ADDENDUM TO THE CONTRACT

BARTLETT REGIONAL HOSPITAL PHARMACY CLEAN ROOM Contract No. BE19-226

ADDENDUM NO.: TWO

ADDENDUM 2

SHEET NO: ESK-1

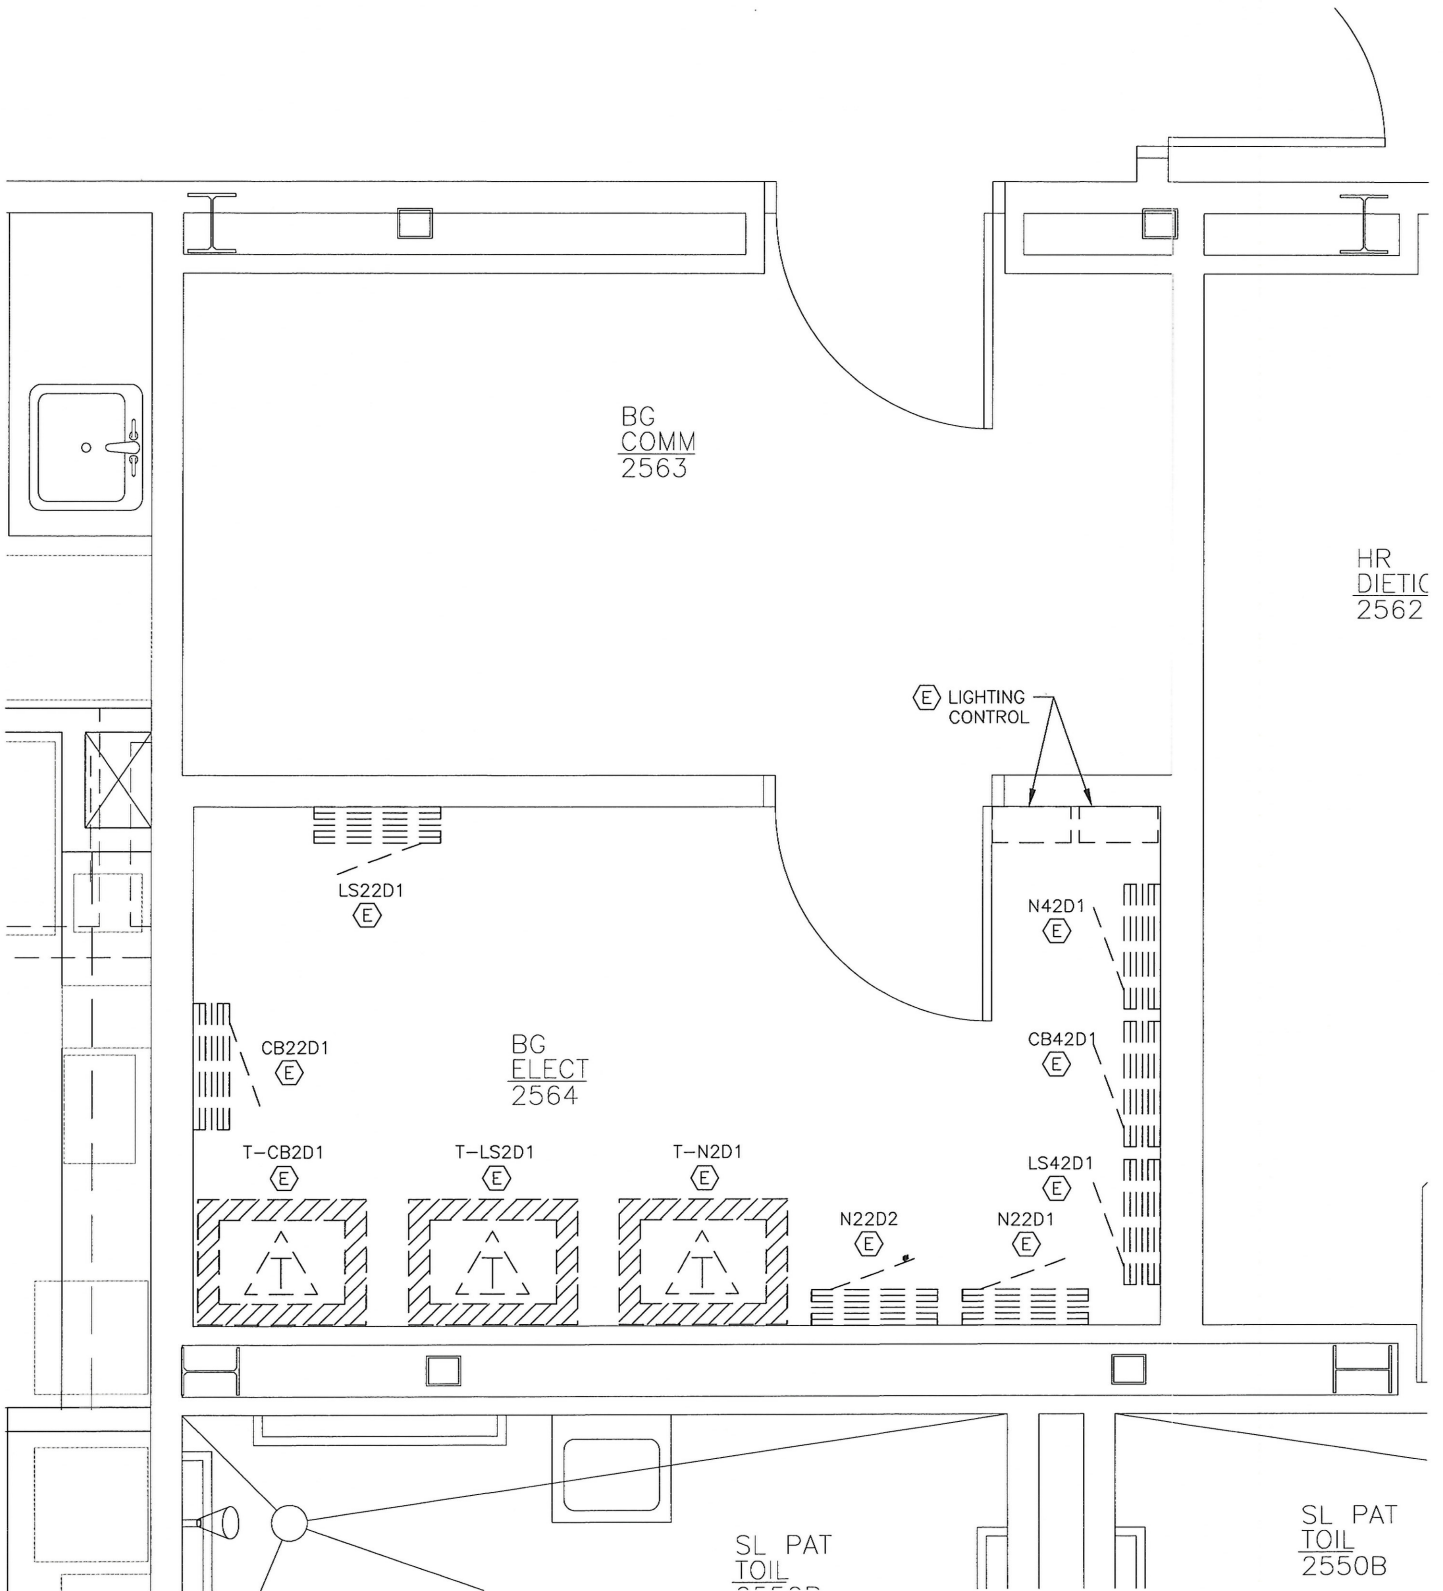
- Item No. 10 Sheet E101, Detail 1
Replace "SEE SHEETS E102, E201, E301, E401" **with** "SEE SHEETS E103, E202, E302, E402".
- Item No. 11 Sheet E102, Detail 1
Revise layout of existing electrical equipment in room BG ELECT 2564. See attached electrical sketch ESK-1.
